# ZM497 AND ZM1497

## SOLENOID SWITCH

### TECHNICAL INFORMATION

#### **NEW SUITABILITY WITH VALEO 594449 AND ADAPTABLE TO STARTERS D6RA110**

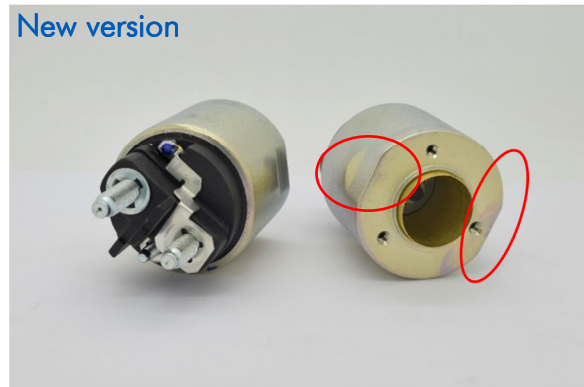
Our Supplier ZM, during range improvement, has changed the solenoid ZM497 drawing. The most visible change (red circles) is the double facet on the body in order to get easy the placement on the specific starter bracket.

Old version

New version

The main goal was enlarge the application list to starter Valeo D6RA110, without open new project.

The result has been obtained with two versions:

- 497, solenoid without plunger
- 1497, solenoid with plunger
